Item No.94 GEAR CHANGE STAY

JAVELIN - ALL MODELS

Further to Item No. 84.

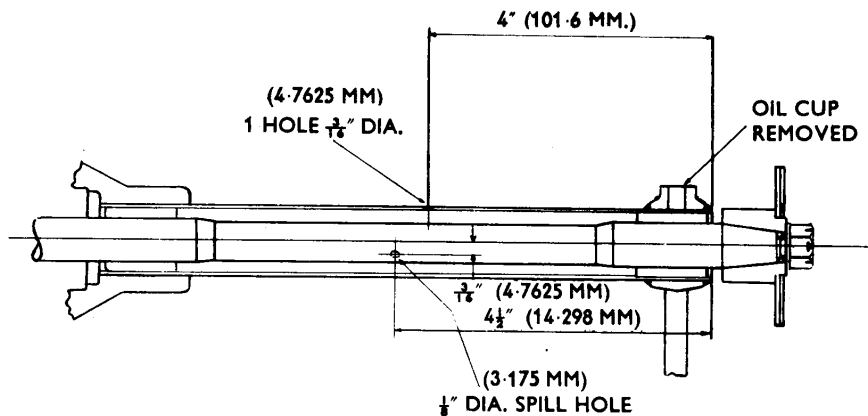
A $\frac{3}{16}$ " (4.7625 mm) hole is now incorporated in the Fan Support Tube for lubrication purposes together with a $\frac{1}{8}$ " (3.175 mm) spill hole to prevent over lubrication.
